Addendum 4

Date: 10/28/22

Addendum 4 Items:

S4.9

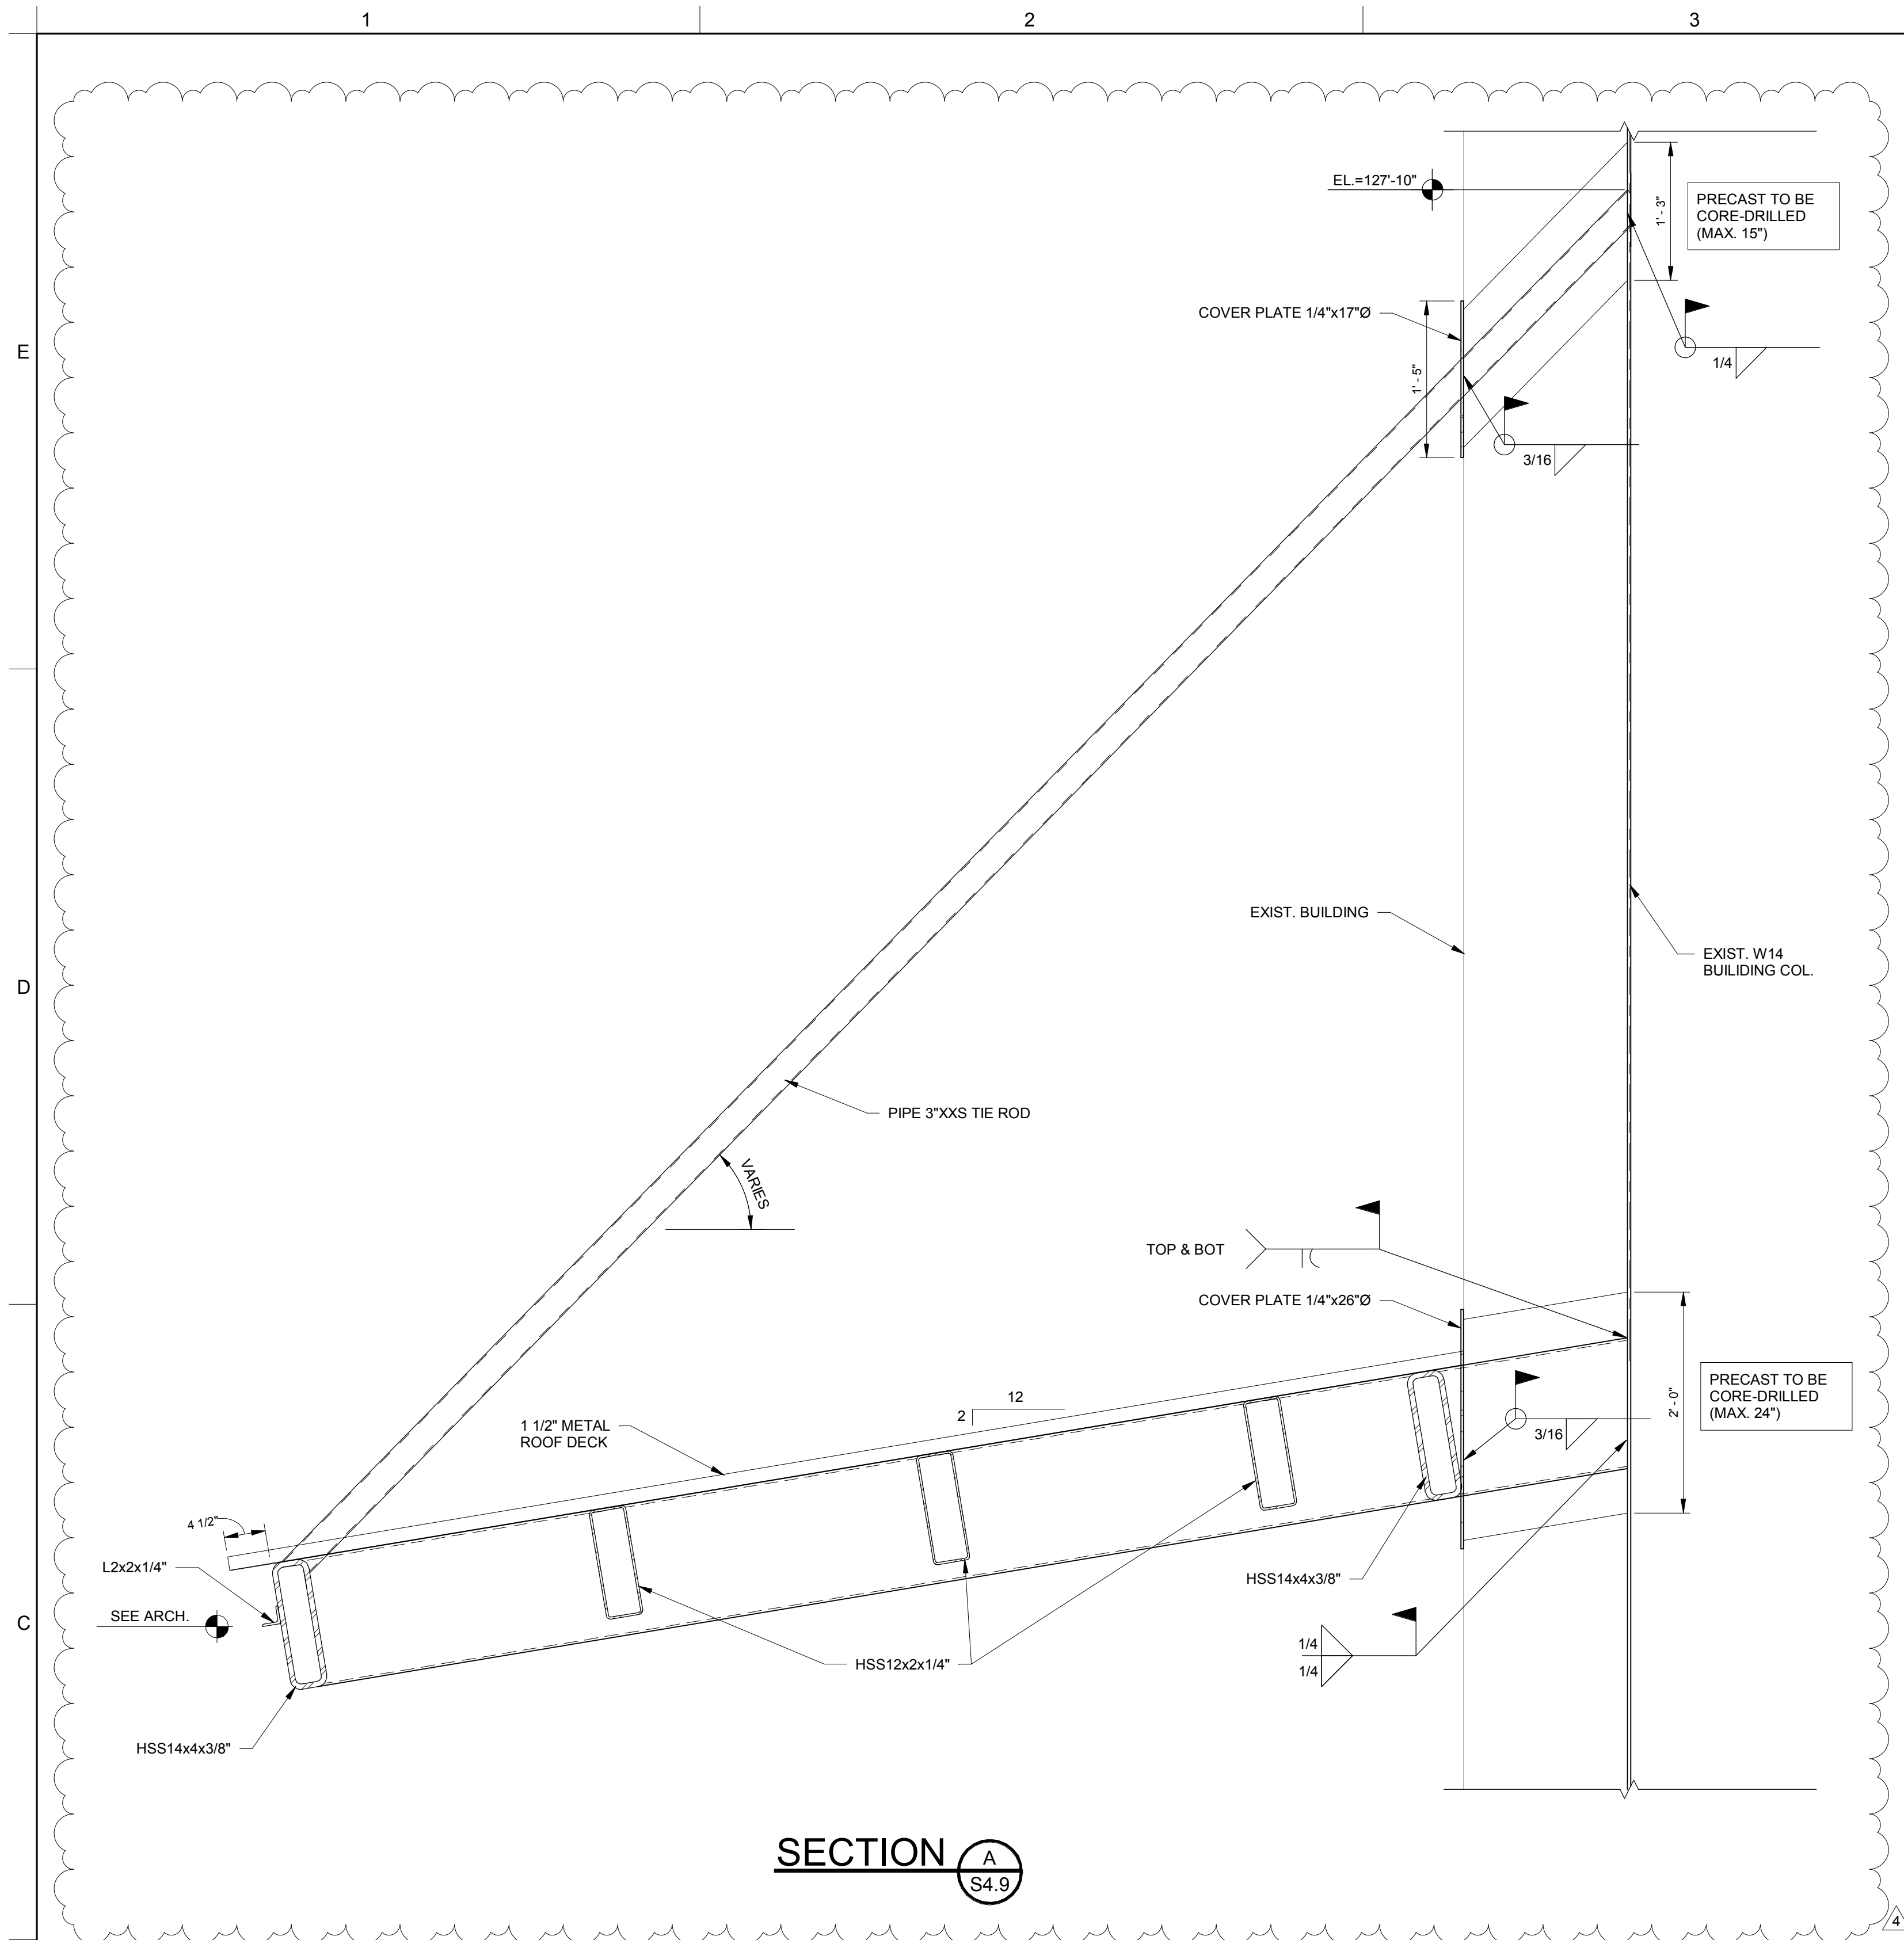
Refer to sheet S4.9

A954b

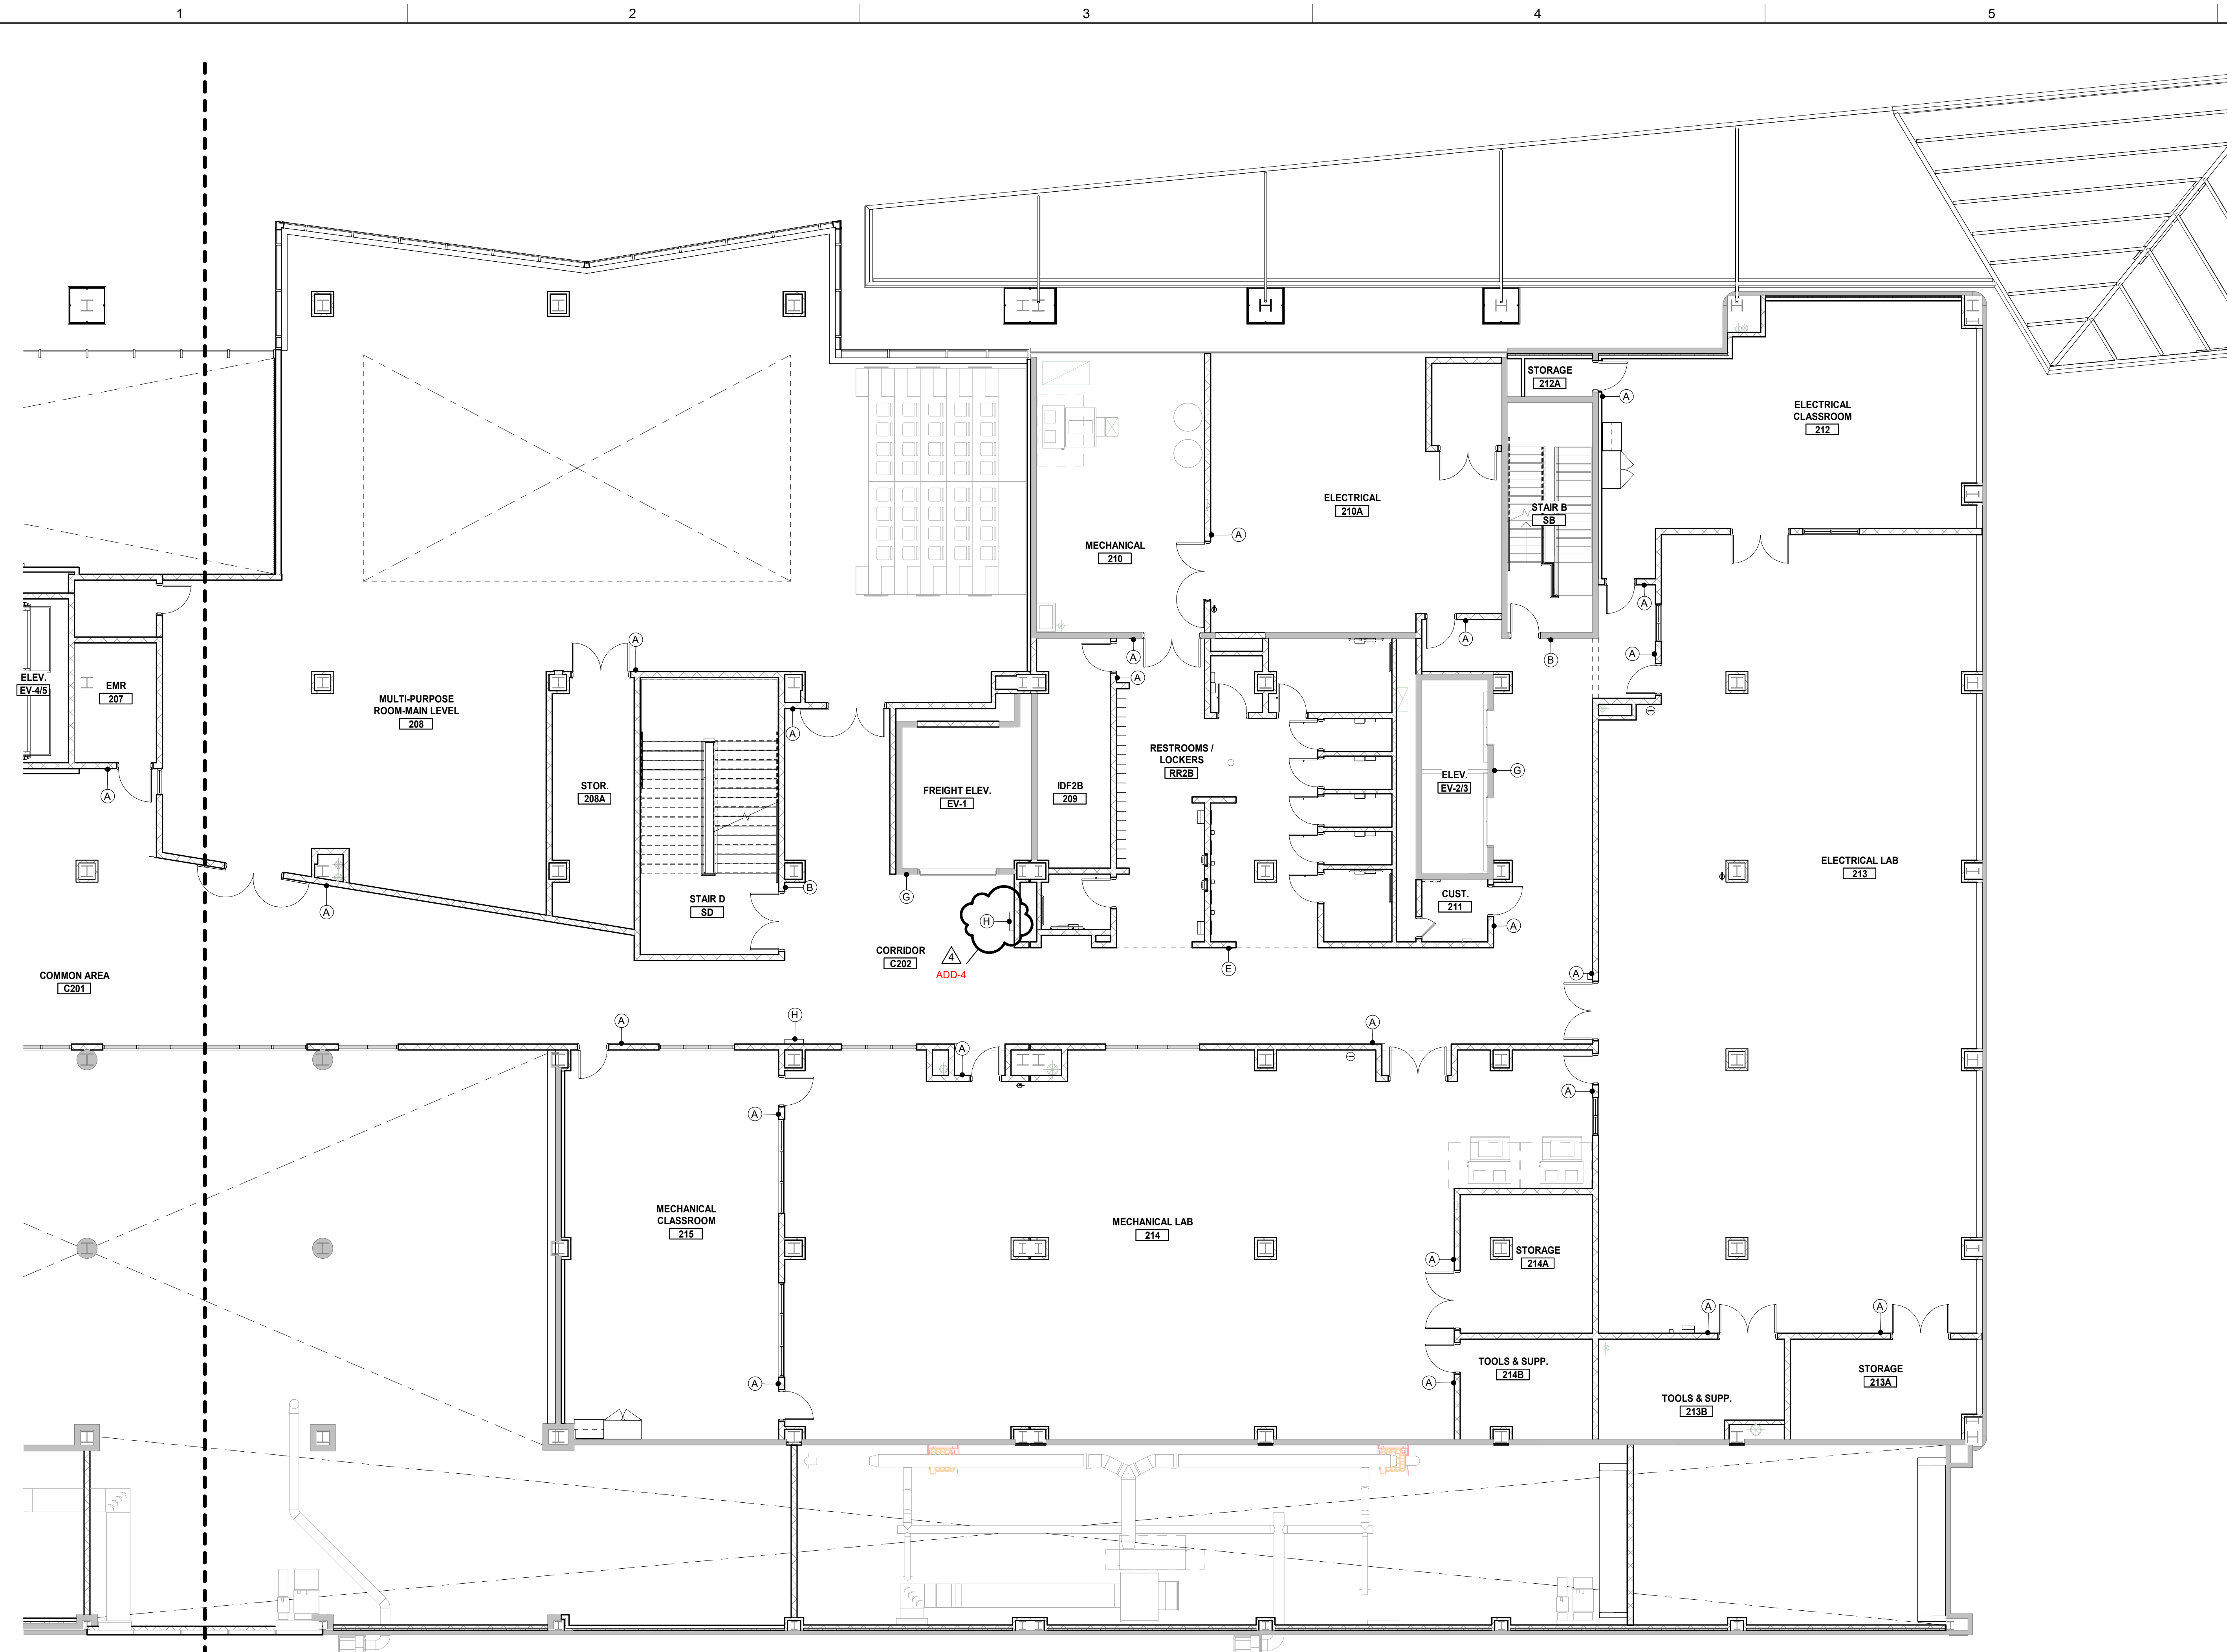
Refer to sheet A950 for updated sign type H Directory reference, and sheets A954b, A955b, A956a for plan locations tagging signage type H which were not all tagged on the bid documents.
